PRODUCT CHANGE NOTIFICATION (PCN)

AMJE0909-0100-BNB-24
MODULAR CABLE

CHANGE NOTIFICATION: PCN 20220509_AMJE0909-0100-BNB-24

DESCRIPTION OF CHANGES:
CHANGE OF DATA SHEET
CHANGE OF DATA SHEET
New Draw.-No. ASS_7945_CArev02

AMJE0909-0100-BNB-24 OLD VERSION

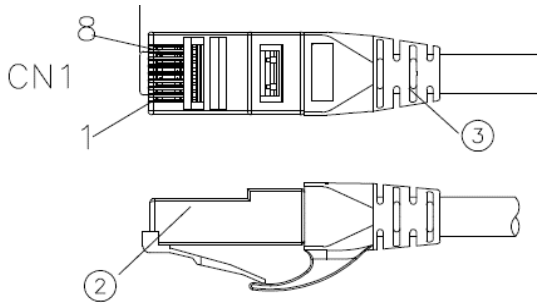
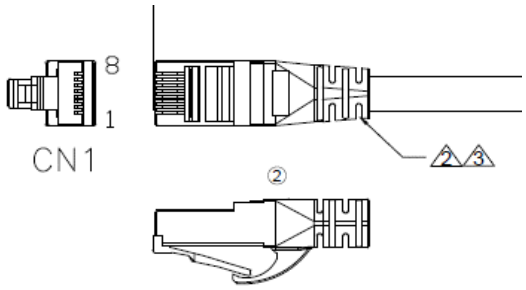
③	Molding	PVC 45P Color: see order code	NA	KG
②	CONNECTOR	RJ45 8P8C two fork Short type 3u" gold plated	2	PCS
①	CABLE	CAT6 UTP (24AWG*1PR)*4+PVC OD=5.8±0.3MM Color: see order code	NA	MM
NO:	NAME	DESCRIPTION	Q'TY	UNIT

3	Molding	PVC 65P Color: see order code ②	NA	KG
2	CONNECTOR	RJ45 8P8C PLUG 3u" gold plated ②	2	PCS
1	CABLE	CAT6 U/UTP (24AWG*1PR)*4+Cross+PVC Jacket OD=5.8± 0.3MM Color: see order code ②	NA	MM
NO:	NAME	DESCRIPTION	Q'TY	UNIT

Drawing-No.
ASS 7945 CA

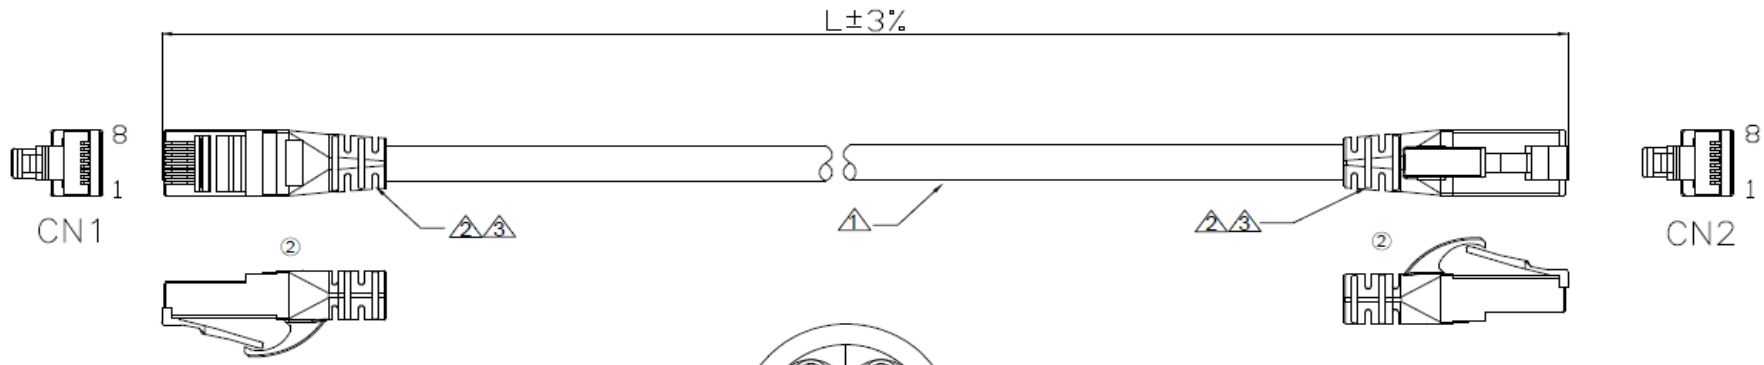
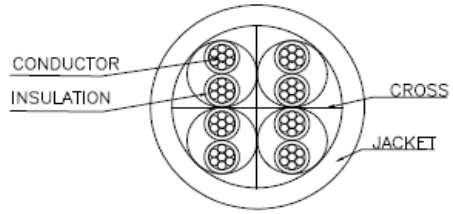
Id.	Modification	Date	Name
②	Change the plant	09.05.2022	Luca
①	Update the WSW order code	02.06.2017	Amy
⓪	Drawn	30.03.2017	Amy

NO:	NAME	DESCRIPTION	Q'TY	UNIT
3	Molding	PVC 65P Color: see order code ②	NA	KG
2	CONNECTOR	RJ45 8P8C PLUG 3u" gold plated ②	2	PCS
1	CABLE	CAT6 U/UTP (24AWG*1PR)*4+Cross+PVC Jacket OD=5.8± 0.3MM Color: see order code ②	NA	MM
